MEETING MINUTES FROM THE
MARICOPA ASSOCIATION OF GOVERNMENTS
STANDARD SPECIFICATIONS AND DETAILS COMMITTEE

2011 PROPOSED REVISIONS TO MAG SPECIFICATIONS AND DETAILS

Date: April 6, 2011
To: MAG Specifications and Details Committee
From: Robert Herz, MCDOT Representative
Subject: Miscellaneous Corrections

Case 11-01 C

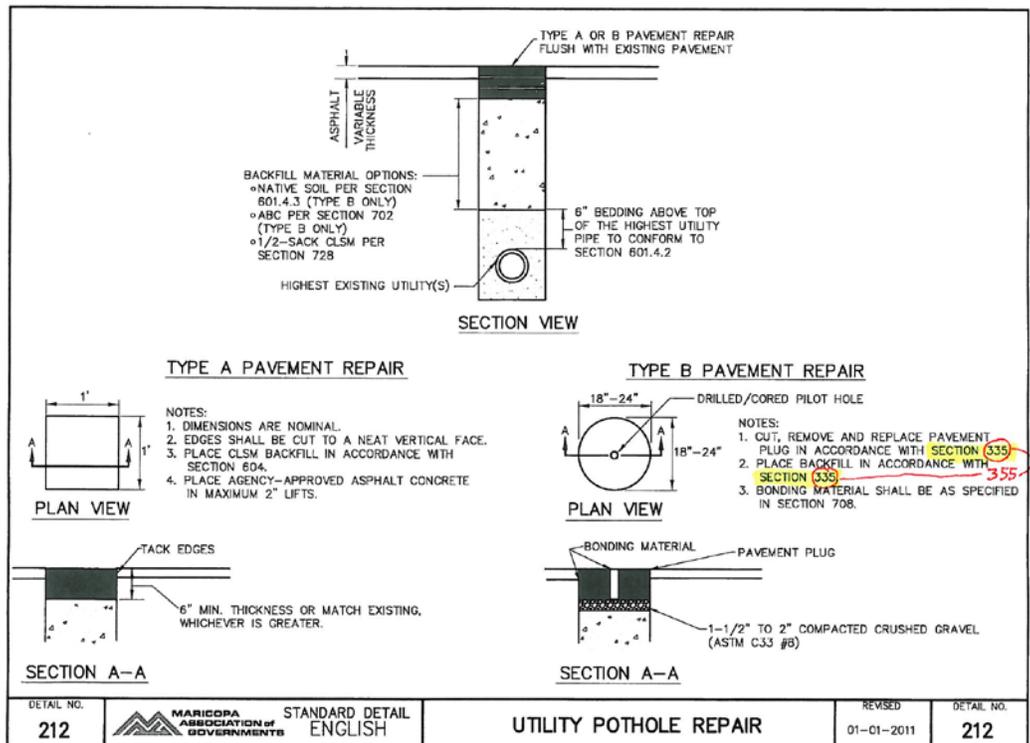
PURPOSE: Correct Detail 212 errors.

REVISION: In Detail 212 under 'TYPE B PAVEMENT' REPAIR change 'section 335' to 'section 355' in Notes 1 and 2.
